Service Bulletin

Bulletin No. 2004-64

CMD Service Bulletin 2004-04 - Alpha / Bravo Stern Drive Improvements

Situation: Product Improvement Changes

Propshaft thrust bearing (Old Design)

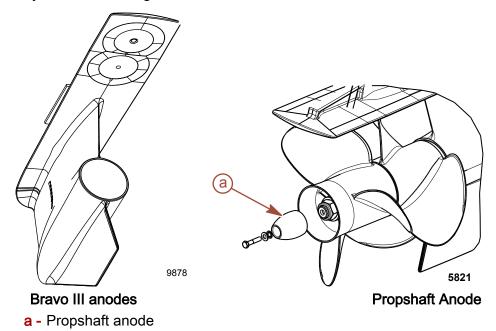
The New Design: Propshaft is identified by the 3 stampings (1 letter, 2 numbers) located next to the oil passage.

The New Design: Propshaft thrust bearing is identified by it's BLACK composite cage.

The Old Design: Propshaft is identified by the 2 stampings (1 letter, 1 number) located next to the oil passage.

The Old Design: Propshaft thrust bearing is identified by it's SILVER steel cage.

Assemble the correct propshaft by identifying the number of stampings located next to the oil passage and identify the propshaft thrust bearing cage.

IMPORTANT: The propshaft thrust bearing and the propshaft are a matched set.
